Village of Arlington Heights
Plat and Subdivision Committee
Community Room
Arlington Heights Village Hall
33 S. Arlington Heights Road
Arlington Heights, IL 60005
August 27, 2014
7:00 PM

- A. Christina Court Subdivision - T1464
1306 & 1310 E. Olive St.
Preliminary Plat of Subdivision

STAFF DEVELOPMENT COMMITTEE REPORT

To: Plat & Subdivision Committee
Prepared By: Latika Bhide, Development Planner
Meeting Date: August 27, 2013
Date Prepared: August 14, 2013
Project Title: Christina Court Subdivision
Address: 1306 & 1310 E. Olive Street

Site Plan Aerial

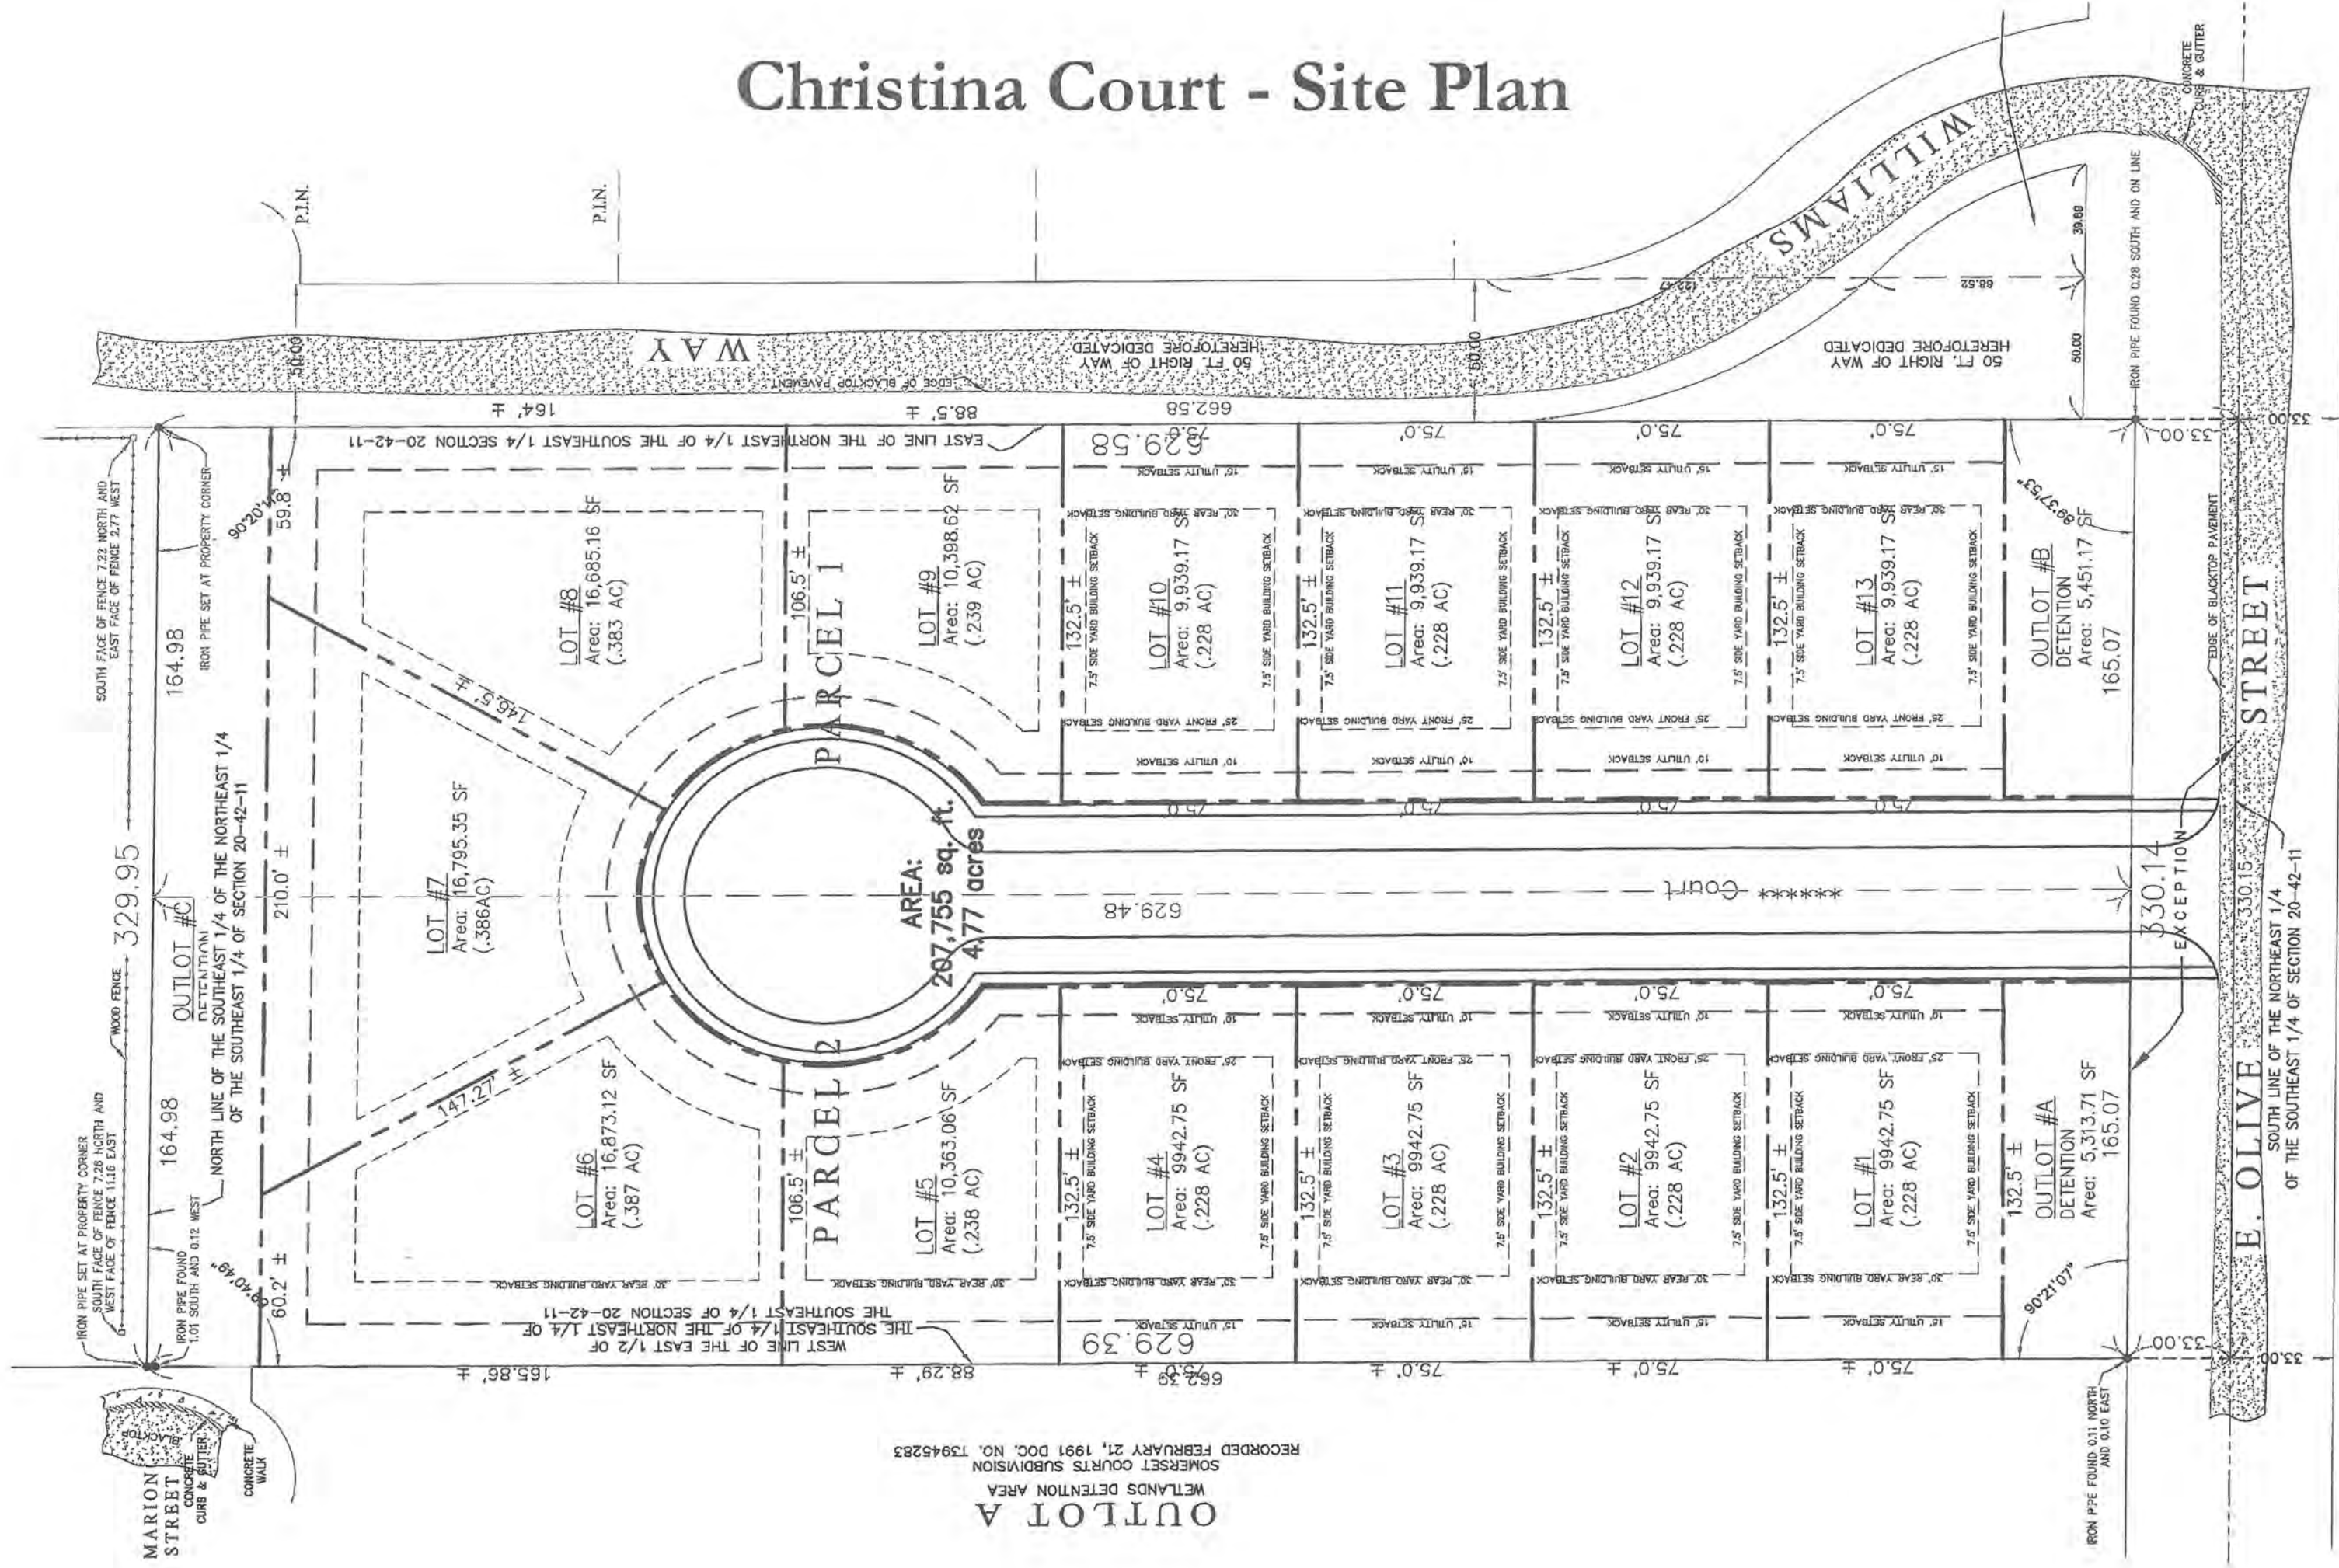
Staff does not support the variations for these outlots the Village requests that the detention is provided on one consolidated lot rather than three smaller lots. Based on the need for access to the detention area, a single detention basin along Olive Street is recommended.

As proposed, a 60-foot right-of-way is proposed for Christina Court. Per Section 29-304, Street Layout & Design, a 66-foot right-of-way is required for a local street, thus a variation is requested. Staff does not support this variation, as the land plan can be amended to accommodate the required width. Staff does not object to the variation for double frontage lots but will require appropriate landscaping of the rear of the lots along Williams Way. Fences are allowed in the rear yards but the lots whose rear yards front on Williams Way should be required to landscape the external side of the fence which would front on Williams Way.

2. Final Plat of Subdivision shall be required separately unless combined with the Preliminary Plat process.
3. Based on the need for access to the detention area, a single detention basin on the south side of the property along Olive Street is preferable.

4. The proposed right-of-way for Christina Court should be revised to 66 feet.
5. Lots whose rear yards front on Williams Way should be required to landscape the external side of any future fences which would front on Williams Way

6. An exhibit showing truck turning movements of the Fire Department's responding vehicle must be provided. The exhibit must show the front and rear wheel paths and the extent of the front and rear overhangs, The vehicle shall be shown, maneuvering through the site in all possible direction of travel.
